RE: OTHER CHANGE REQUEST TO APPROVED DEVELOPMENT PERMIT FOR COMBINED MATERIAL CHANGE OF USE FOR A WAREHOUSE; AND OPERATIONAL WORK FOR CHANGE TO GROUND LEVEL – COM/2023/162

AT: 10 HOMESTEAD DRIVE, STAPYLTON QLD 4207 – LOT 122 ON SP329476

This change application seeks the inclusion of a new land use (Low impact industry) to allow for the storage of dangerous goods within part of the approved Warehouse. This change also involves a new State referral trigger under Schedule 10, Part 7 of the Planning Regulation 2017 as the new use involves a Hazardous Chemical Facility. This change application remains code assessable.

Figure 2 – Proposed site layout (GDP file, 2024)

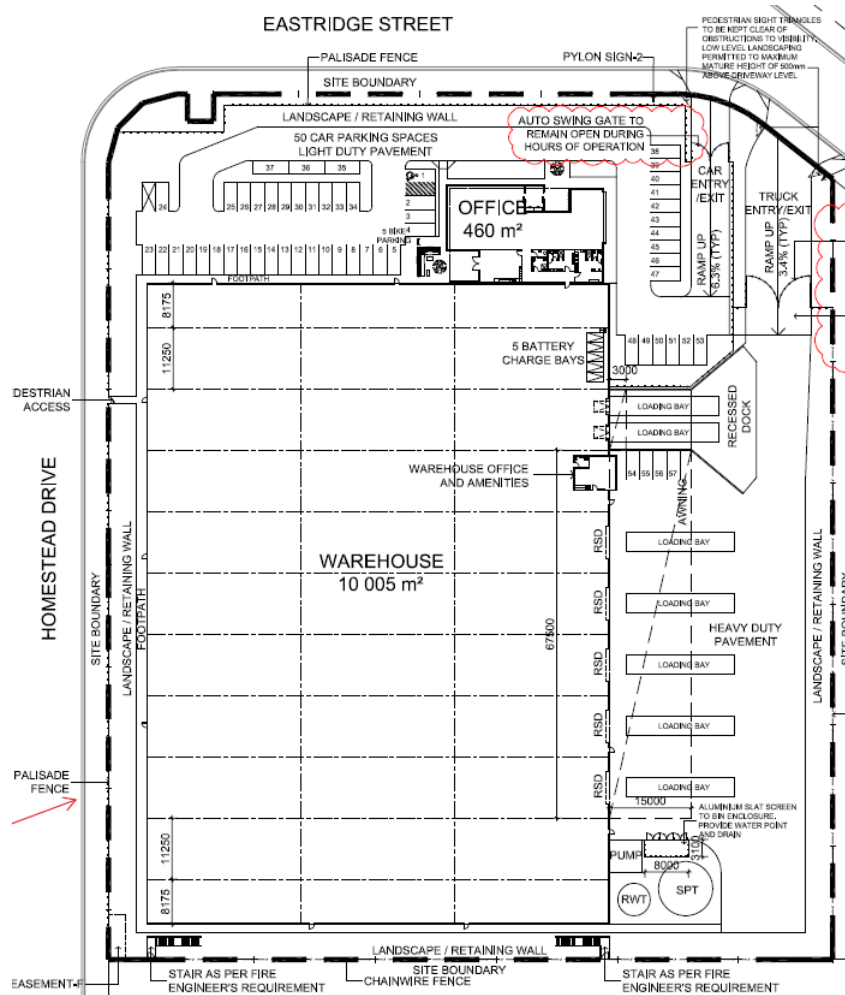
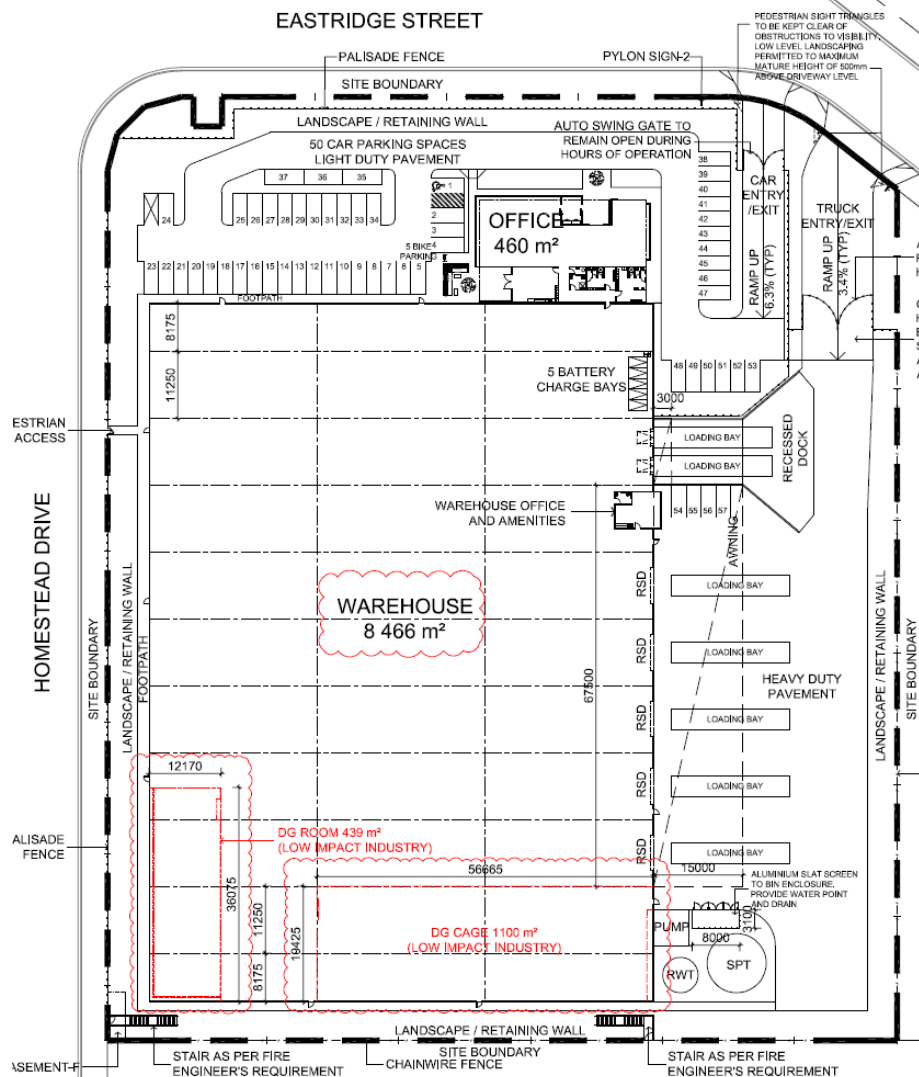
This change application seeks to introduce a new land use to allow for the storage of dangerous goods (DG) within part of the approved Warehouse. Amendment to Condition 25 of the approval is also proposed to correct an administrative error.

It is proposed to introduce two DG storage areas within the approved Warehouse, totalling 1,539m² (about 15% of the warehouse GFA). A 439m² DG room is proposed in the south-western corner of the Warehouse and a 1,100m² DG cage is proposed in the south-eastern corner of the Warehouse.

An extract of the proposed site layout is shown in **Figure 2** below. A copy of the amended proposal plans is provided within **Attachment D**.
